**MEMORANDUM**

**REVIEW TYPE:** Preliminary Plan Review, Resubdivision of existing Lot 2, Block J, Allanwood

**PROJECT NAME:** Allanwood

**CASE #:** 120070400

FIGURE 33

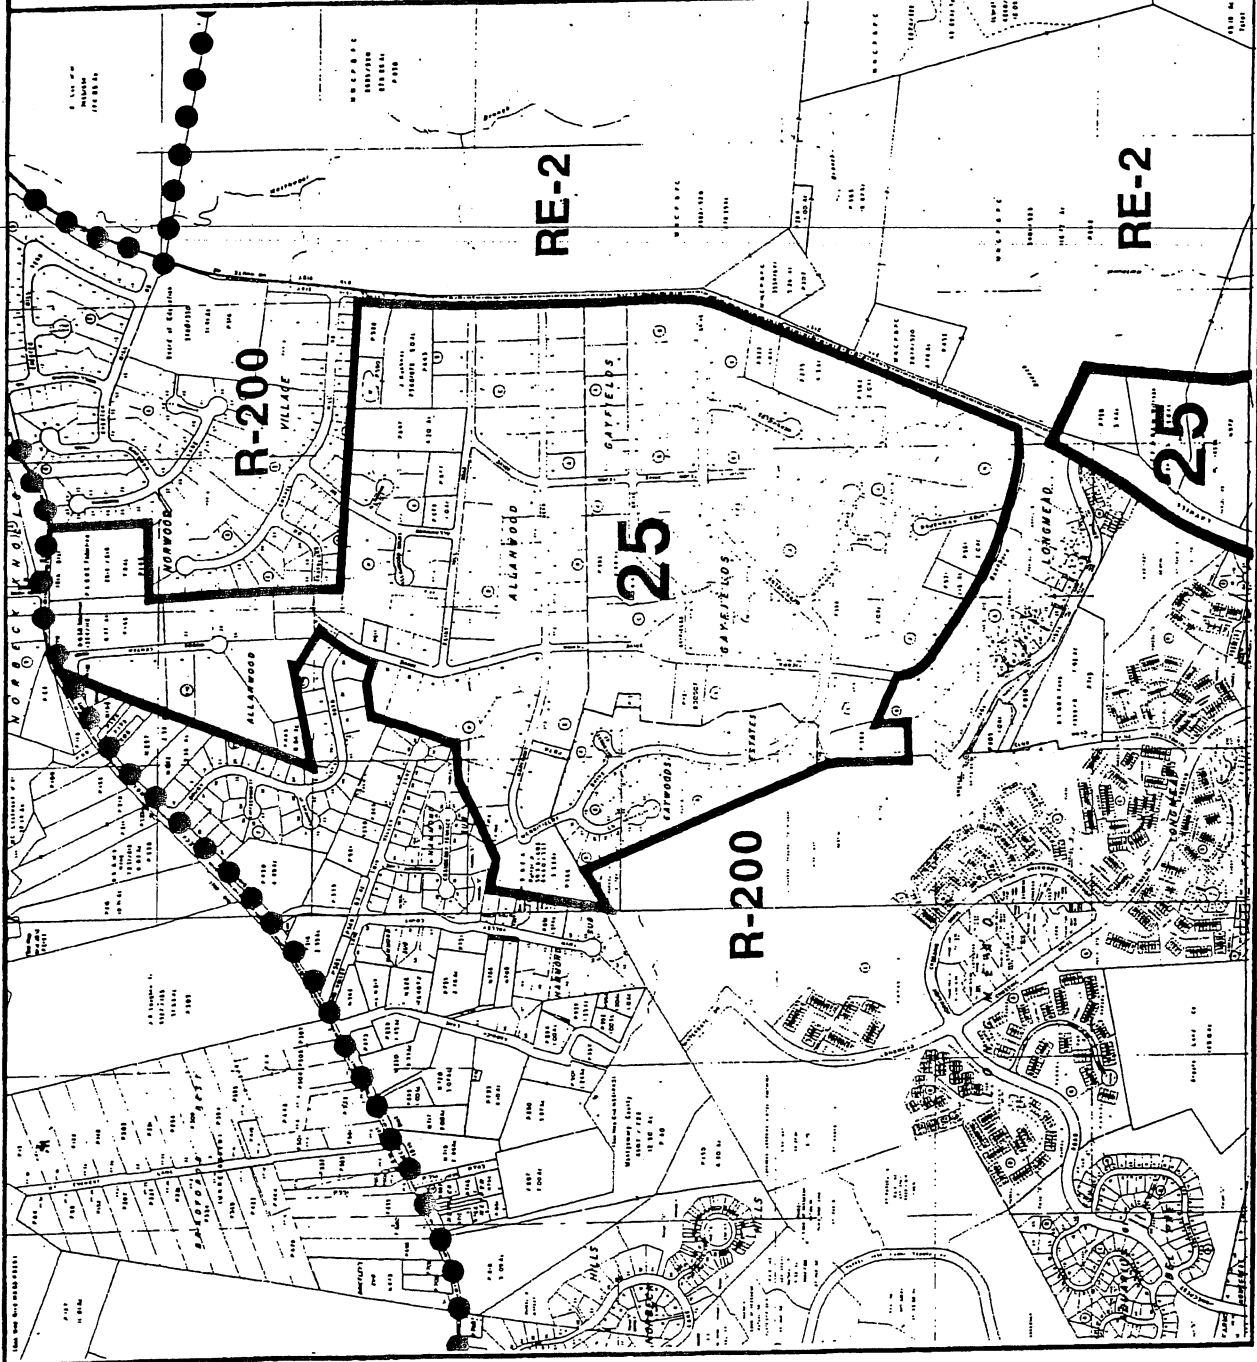
The Aspen Hill Master Plan graphically draws the line that separates Site No. 25 and the Woods Center Road lots along the common property line that separates Allanwood II from the rear yards of those lots along Woods Center Road. (See Aspen Hill Master Plan, Figure 33, page 78.) A boundary line drawn in a master plan should not be ignored during the subdivision approval process.
